Field campaign

Topic	V8T & W12 Incorrect warning label fitted (SC12/12)
Market area	Russische Föderation (5RU), Russian Federation 935 Volkswagen Group RUS (6935), United Kingdom E01 Bentley UK (6E01), Germany E02 Bentley rest Europe (6E02), Australia E04 Bentley rest Asia and Australia (6E04), United States E05 Bentley USA and rest America (6E05), United Arab Emirates E06 Bentley Middle East and Africa (6E06)
Brand	Bentley
Transaction No.	2030735/1
Campaign number	E772
Note	
Type	
US code

Technical background

Figure 1

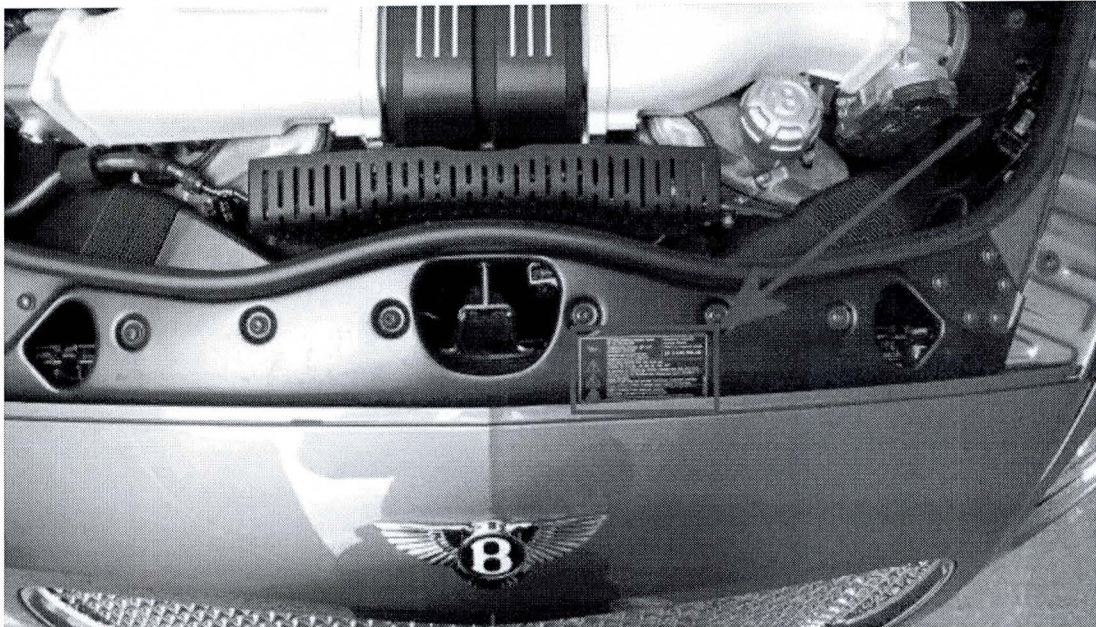
A small number of Continental Series vehicles may have had the incorrect warning label fitted at the time of production. Figure 1 shows the fitting location of the label, the labels are very similar in appearance to each other, the main difference relates to the oil grade which must be used dependent on engine derivative. W12 Continental Series vehicles should have the label as shown in Figure 2, the V8T Continental Series vehicles should have the label as shown in Figure 3

The warning label is fixed to the front end module closing plate, all cars post VIN SCBEN53W5EC [REDACTED] are fitted with the correct label at the time of production extra quality checks have been implemented to ensure correct warning label fitment.

Figure 2

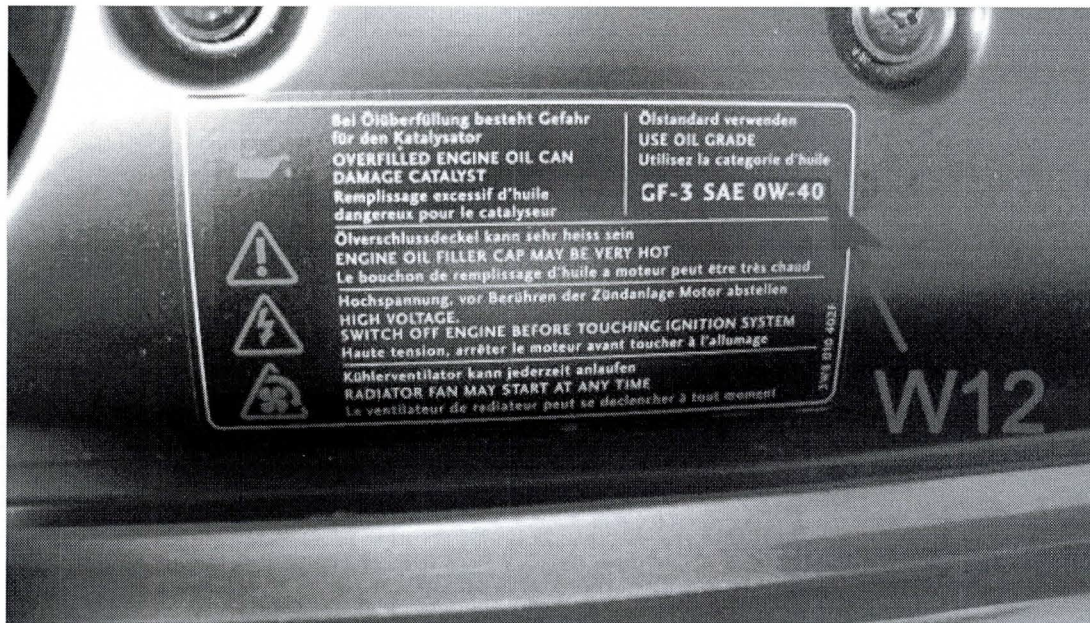
1. Check the correct label is fixed to the closing panel dependent on engine type, W12 Continental Series should be as shown in Figure 2, V8T Continental Series should be as shown in Figure

3. Should the incorrect label be found to be fitted and does not correspond with the engine type please replace the label taking note of the following key points:

Carefully peel off the existing label, should the label not peel off with ease the use of the heat gun supplied with the workshop tool VAS 1978B is recommended, use on a low setting and with care warm the label to ease removal.

- Using a plastic spatula with care remove the label from the closing plate
- Before fitting the replacement label thoroughly clean and dry the affected area
- Apply the new label

Figure 4

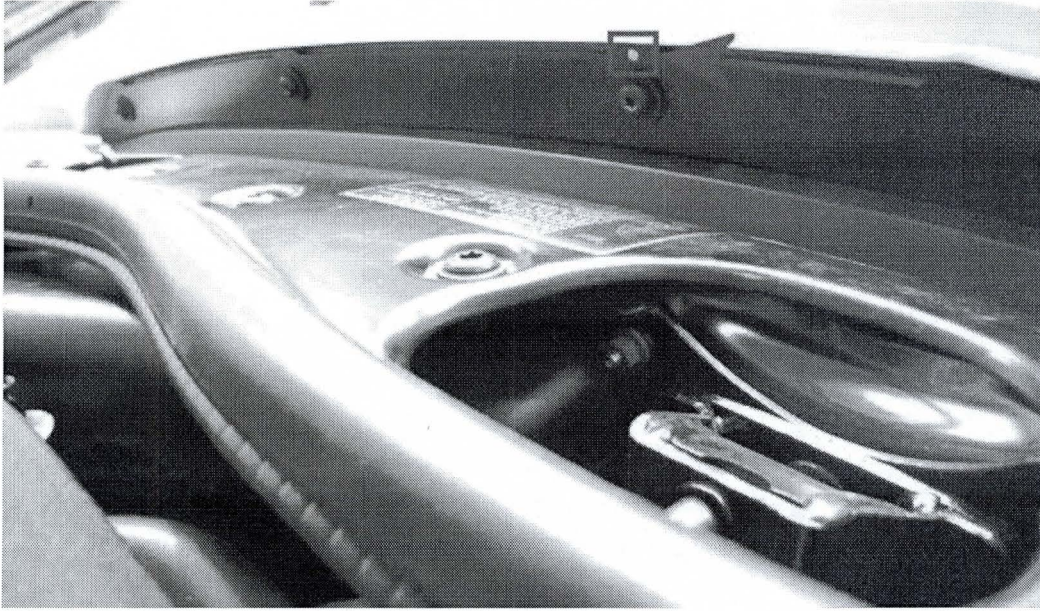
If the vehicle is not already listed as repaired in the "Repair history" (in Elsa pro), check for the campaign identification mark which is a small White paint dot located above the radiator shell fixing directly above the label (Figure 4) should neither be evident carry out the required work in accordance with instructions

2. Once the check has been conducted or the label has been replaced place a small white confirmation mark above the radiator shell fixing which is directly above the label (Figure 4)

Small White confirmation paint dot above the radiator shell fixing (Figure 4)
